HONDA

Product Update: 2016-18 Civic: Software Update with A/C Control Unit Replacement; DTC P0300, P0301, P0302, P0303, P0304, or P0172

Supersedes 18-137, dated January 8, 2019, to revise the information highlighted in yellow

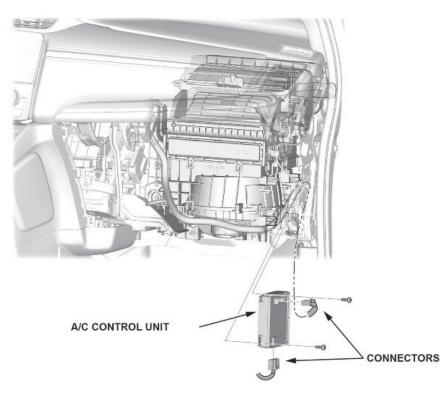
- 1. Reset the maintenance minder.
- 2. Drain and refill the engine oil. Do not replace the oil filter.
- 3. Replace the A/C control unit.
 - 3.1. Remove the dash side lid and the undercover.

3.3. Remove and replace the A/C control unit.
